City of Fredericksburg

Planning and Zoning Meeting Agenda
Wednesday, June 7, 2023 ~ 4:30 PM
Law Enforcement Center
1601 E. Main Street
Fredericksburg, Texas 78624

PLANNING AND ZONING COMMISSION **AGENDA MEMO**

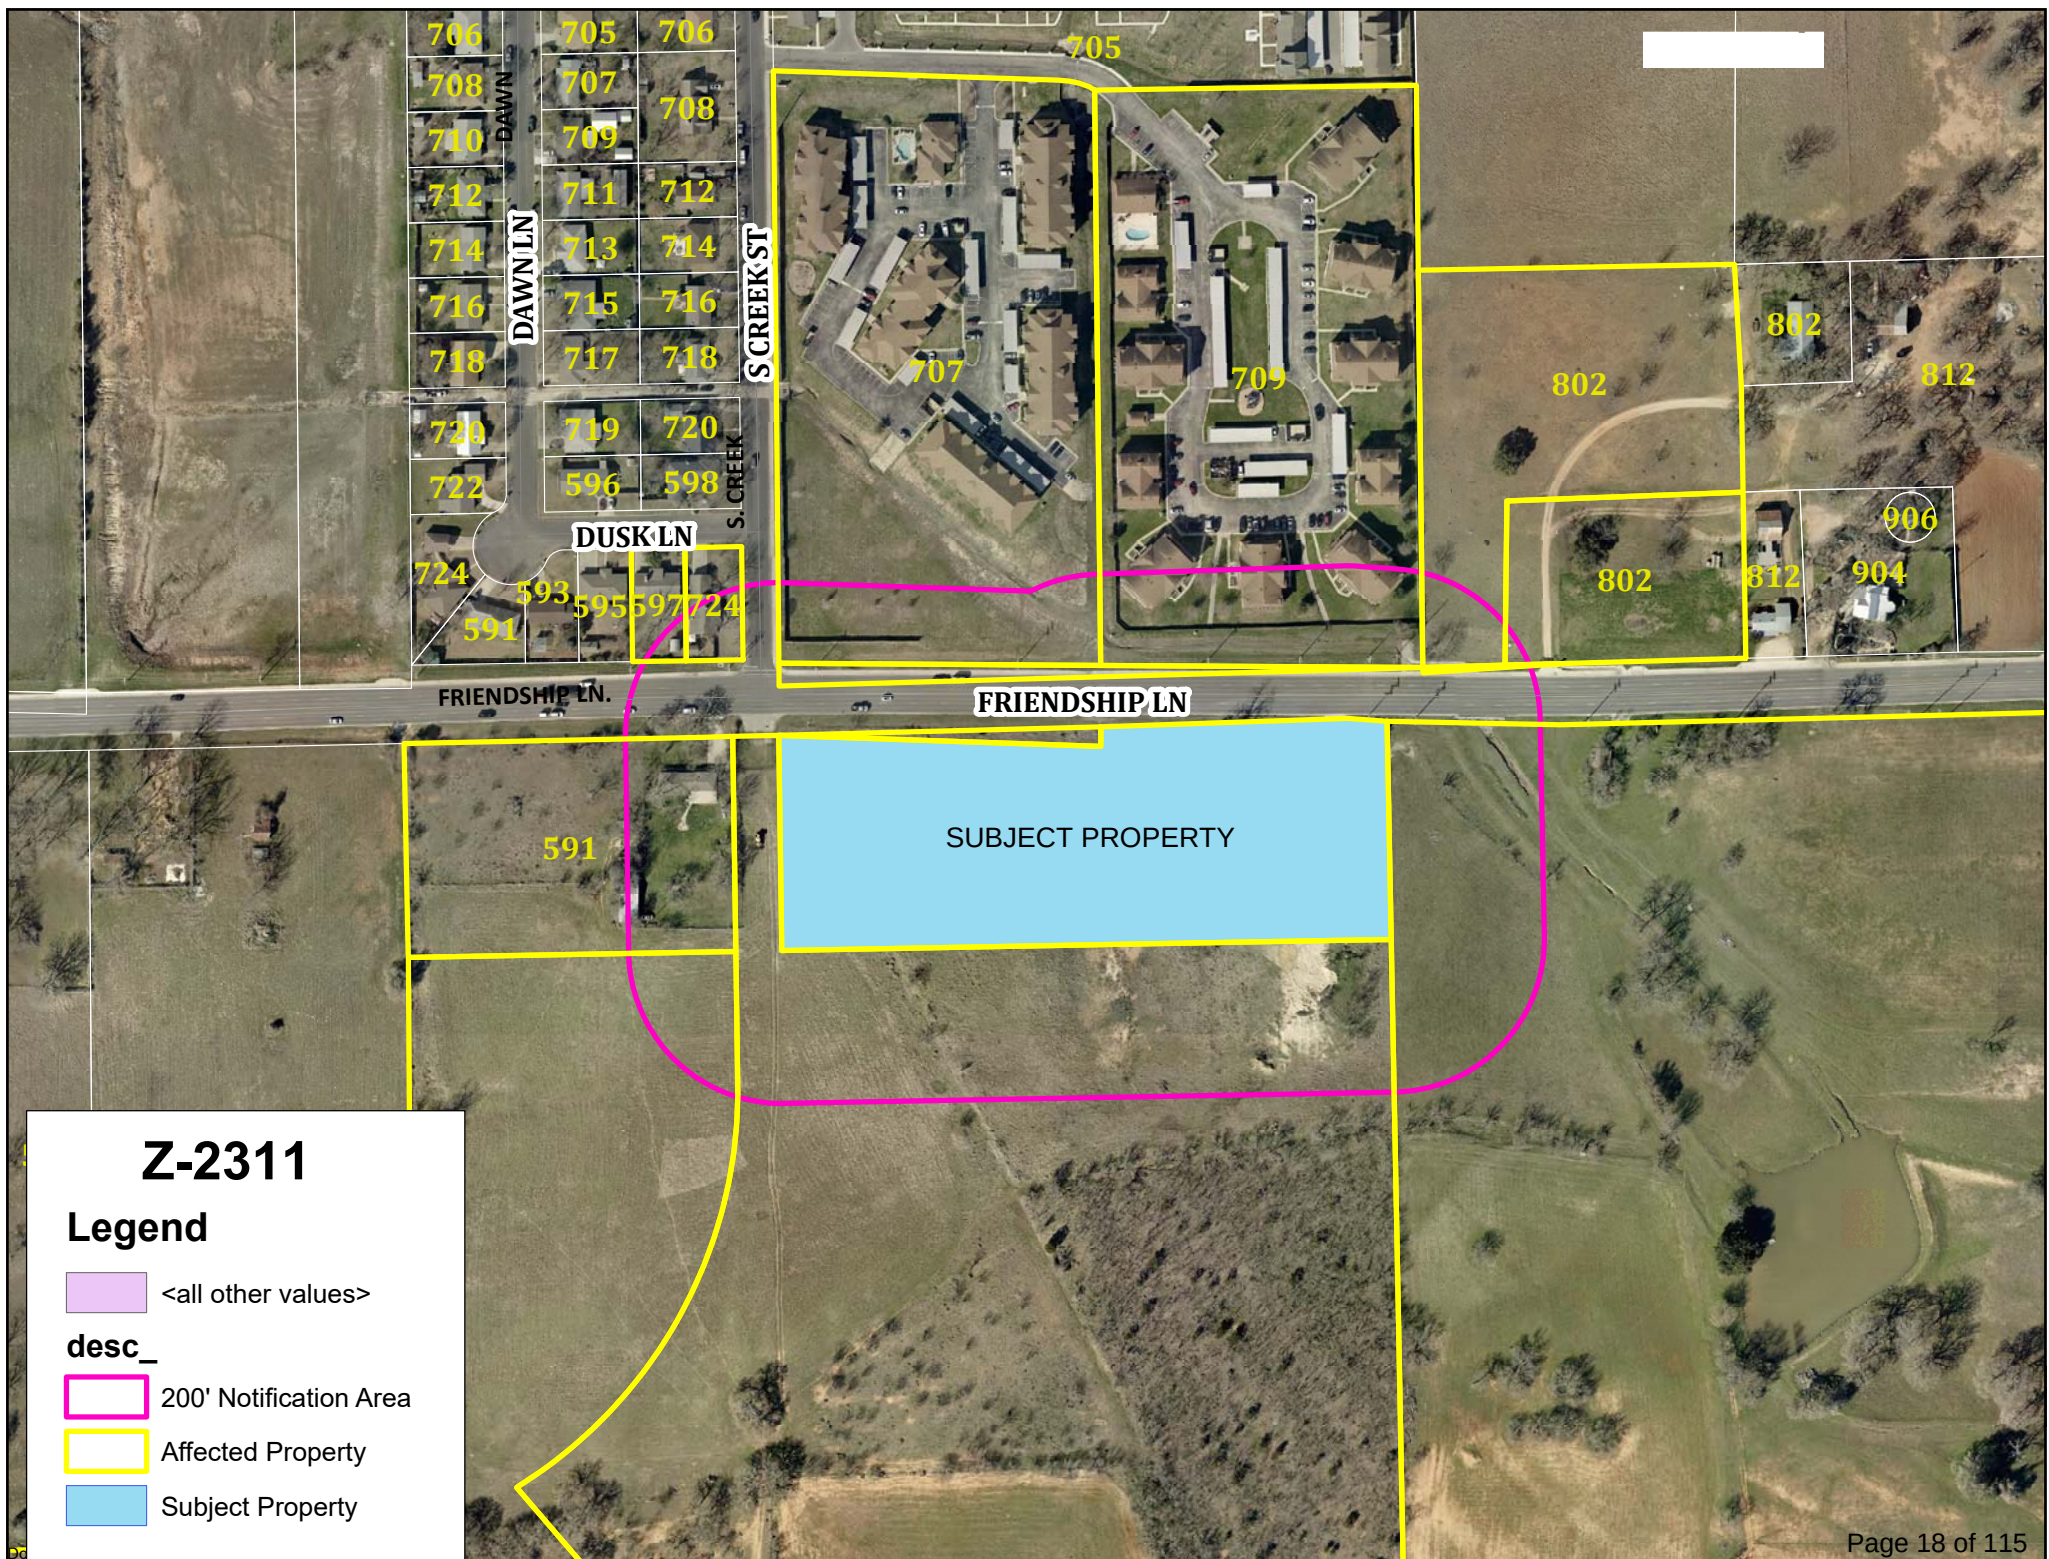
2. Provide Zoning Summary per Sec. 3.110.

3. Provide Impervious Cover Calculations per Sec. 3.110 – Site Plan Checklist.

4. Provide Building Coverage calculations per Sec. 3.110 – Site Plan Checklist.

5. Provide Building Height per Sec. 3.110 – Site Plan Checklist.

6. Provide location of solid waste container Sec. 3.110 – Site Plan Checklist.

8. Please update the Zoning Summary to include Parking Calculations (Condominium Residential) and dimension all parking spaces to show compliance with Sec. 7.863 and Sec. 3.110.

9. Please provide an addressing plan Sec. 7.131.

12. Please provide a note regarding all exterior lighting shall be night sky compliant. Provide the requested Fixture Type Article XV – Outdoor Lighting – Site Plan Checklist.

13. Provide location of existing landscaping/trees Sec. 7.131-Sec. 7.920 – Site Plan Checklist.

A Zoning Summary Table has been added to the Conditional Use Permit Plan. Note 1 is the zoning summary narrative.

Impervious cover maximum requirements and proposed impervious cover calculations have been added to the Zoning Summary Table.

Building coverage maximum requirements and proposed building coverage calculations have been added to the Zoning Summary Table.

Building height maximum requirements, and proposed building heights have been added to the Zoning Summary Table.

Note 2 addresses solid waste.

A “Parking Analysis Condominium Residential” Table has been added to the Conditional Use Permit Plan. Additional dimension have been added to the parking as well.

Building unit numbers have been added to the Conditional Use Permit Plan.

Note 5 has been added to the Conditional Use Permit Plan, and attached is a sample fixture specification, although no fixtures have been selected at this time.

There are no existing landscaping/trees located on this site.

A
SITE PLAN
FOR
**S. ADAM ST.
COMMERCIAL**

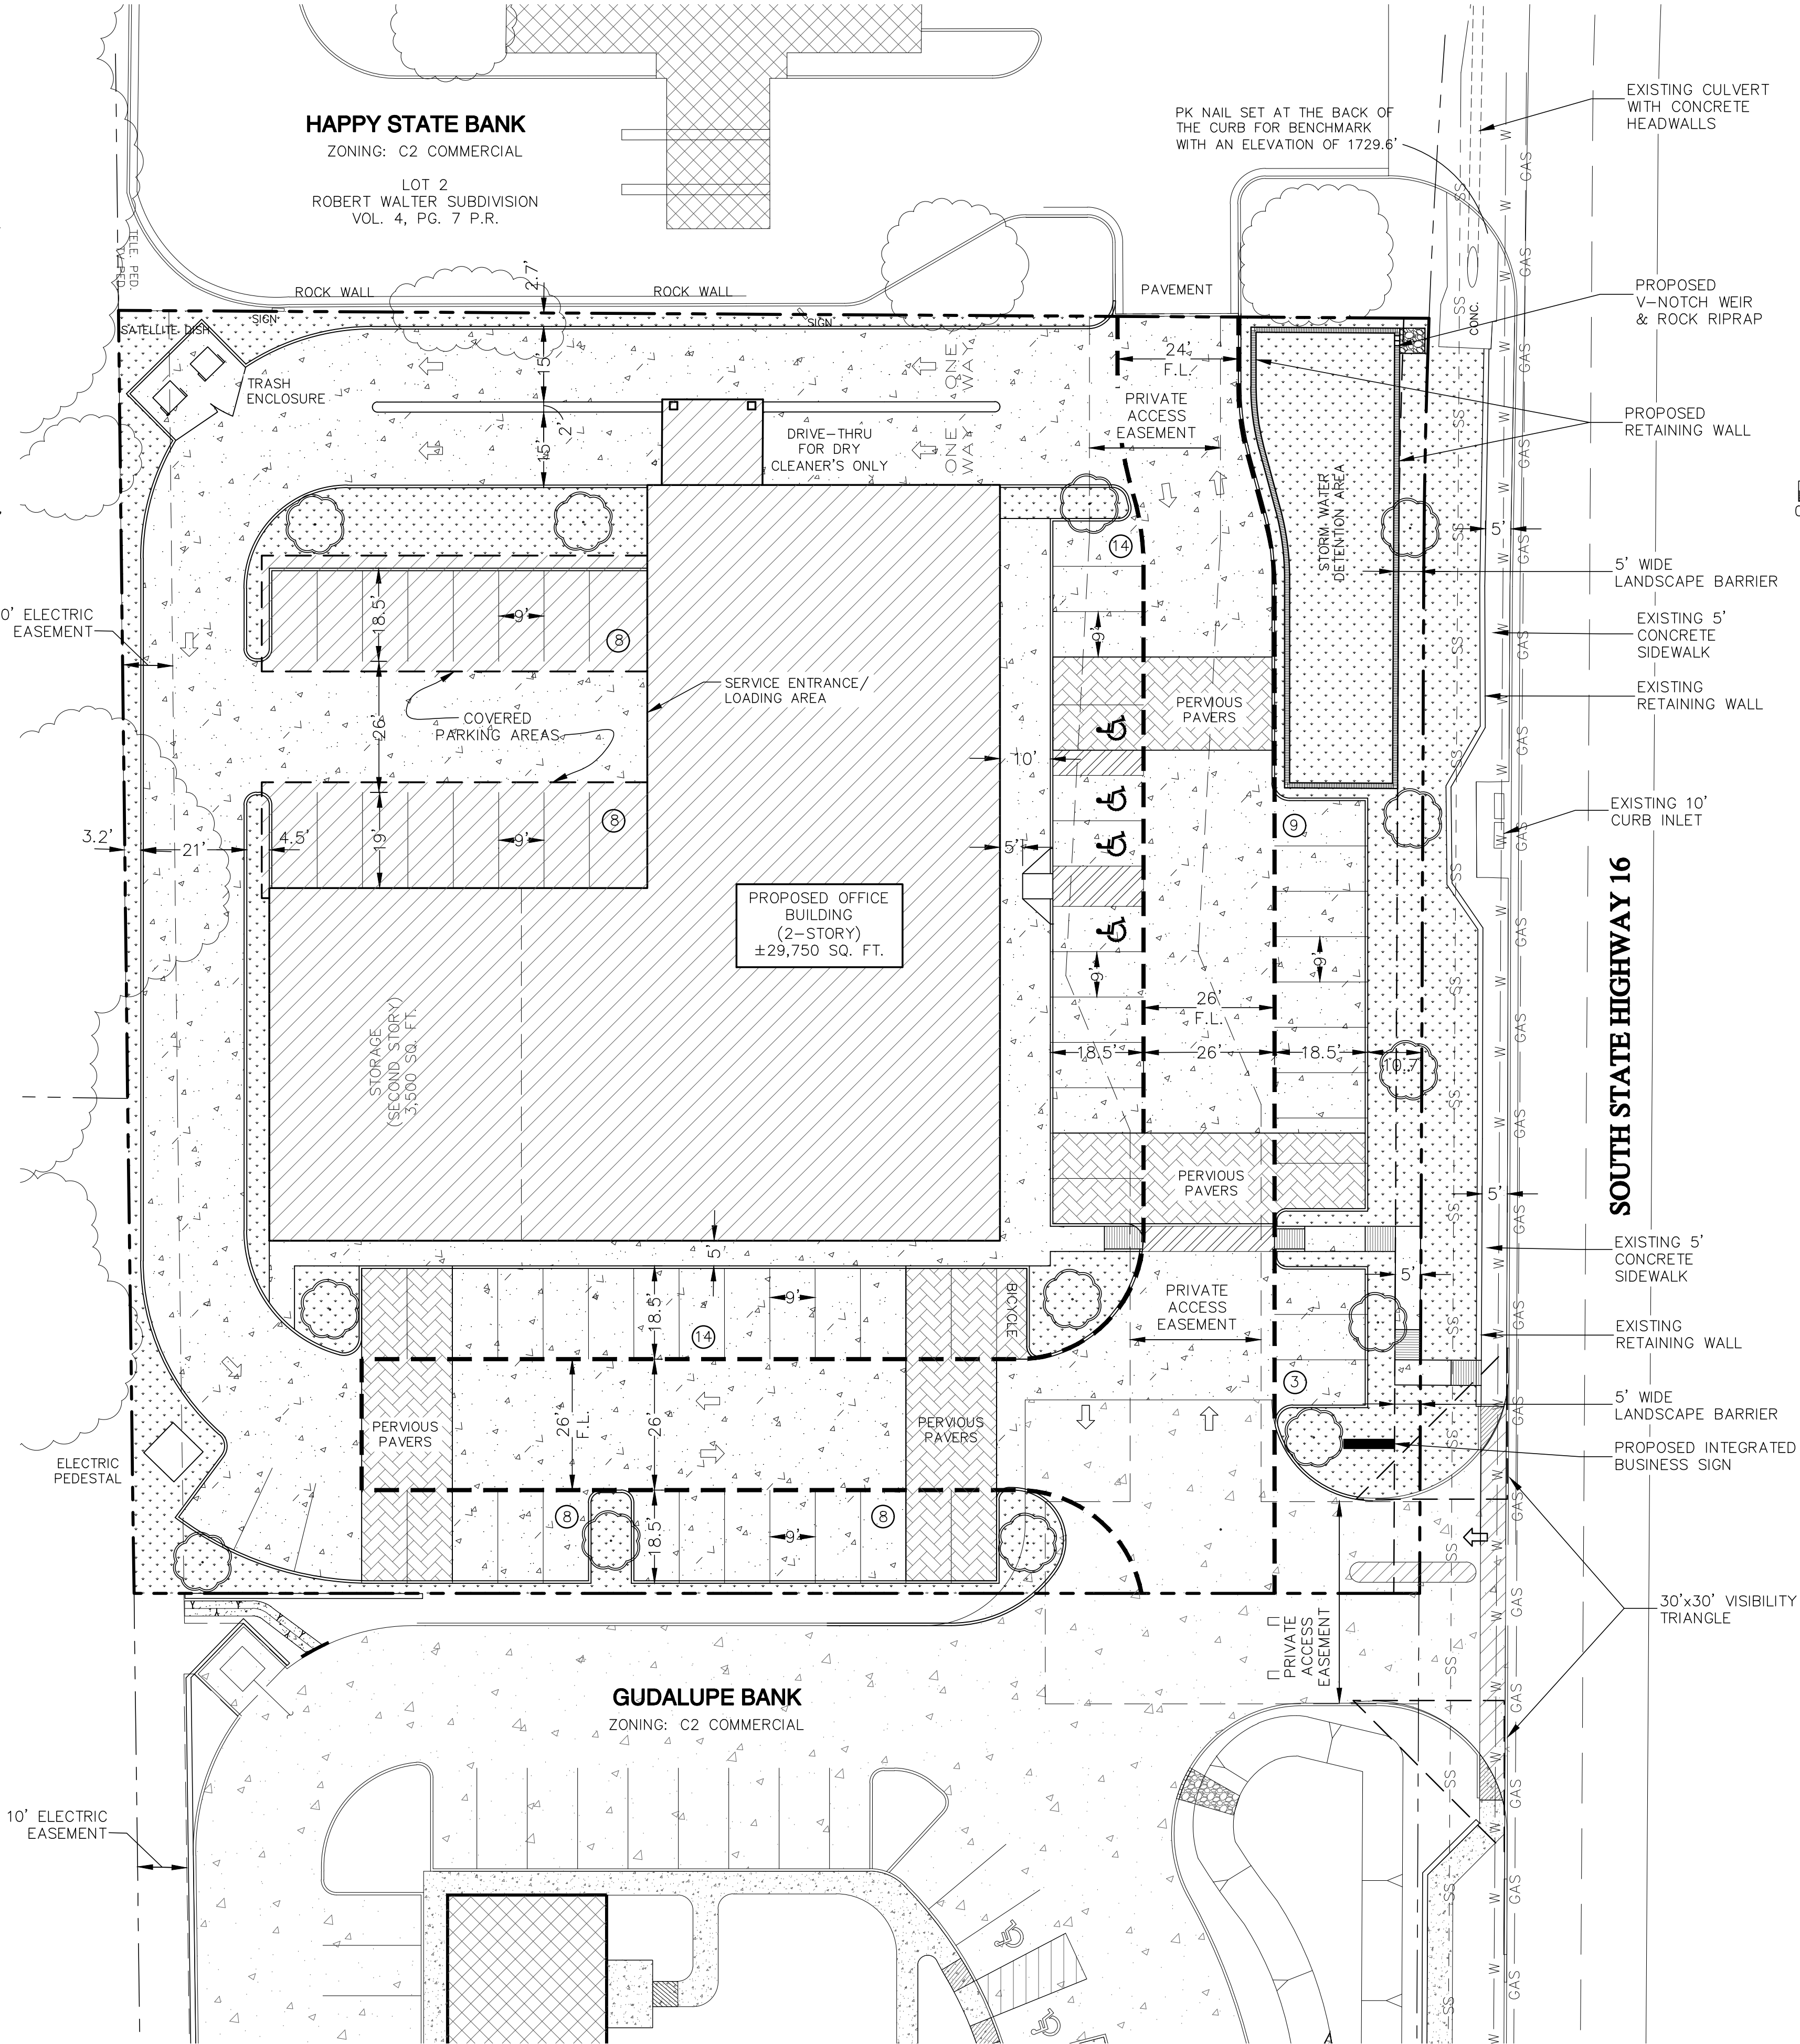
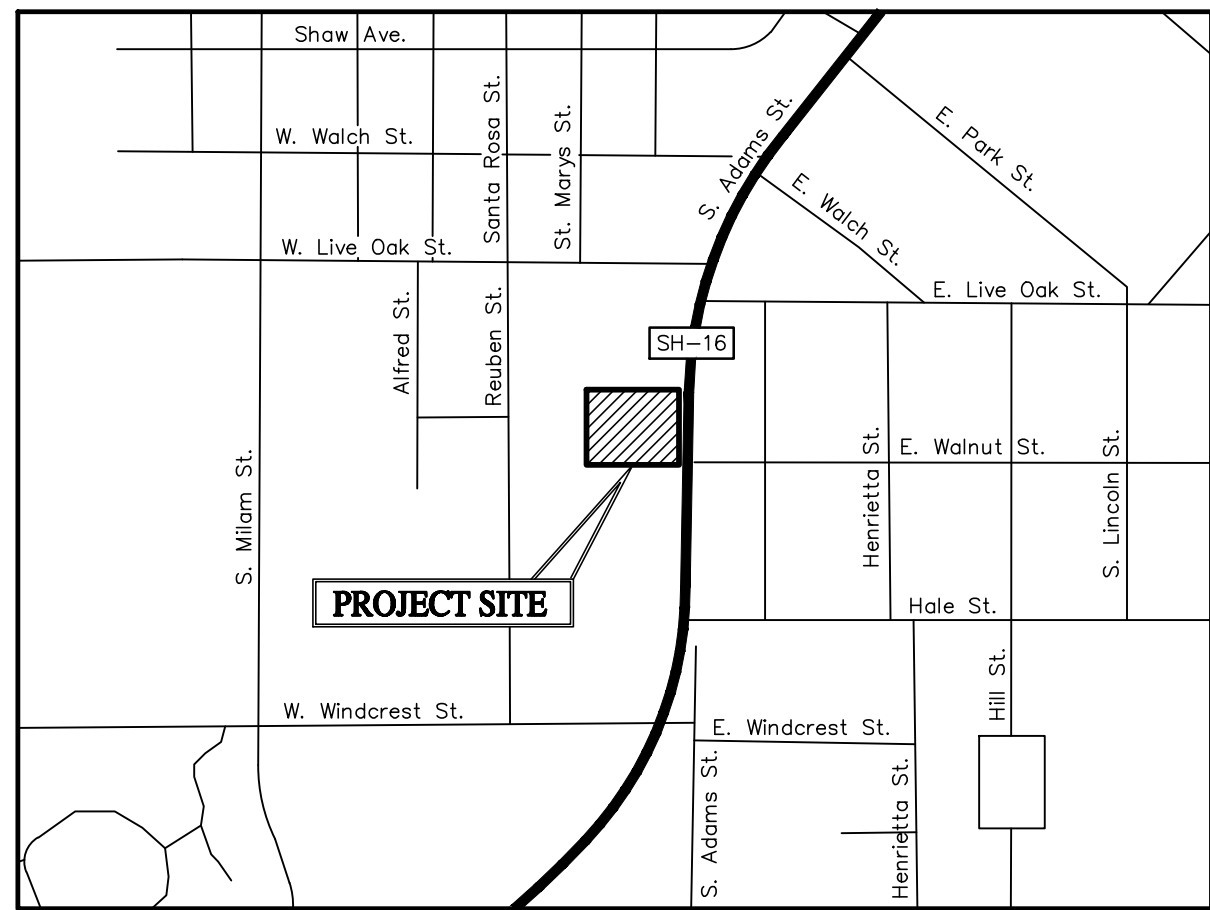
7. *Provide a note regarding all exterior lighting shall by night sky compliant. Provide the requested fixture type Article XV- Outdoor Lighting.*

9. *Please provide an integrated business sign for the development. Sec. 29-3 and Sec. 29-7.*

13. *4" trees per 8 parking spaces to be planted in beds located of parking lots and "islands" Entry Corridor Design Standards Sec. 12.5*

A note has been added to the Site Plan that all exterior lighting will be Dark Sky Compliant. Examples of the type of lighting that will be placed in and around the building are below. Once a decision on the lighting is reached, it will be submitted to the City for approval.

Comment noted. We have connected to the existing sidewalks on S. Adams St. Adjacent sites do not have sidewalks to which we can tie to from our building.

Comment noted. Please see the Landscape & Screening Plan for more details. There are a total of 72-parking spaces in the revised Site Plan, which will require a total of nine (9) four-inch trees. The Plan calls for thirteen (13) 4-inch trees.

A bicycle parking area and facility has been added to the plan.
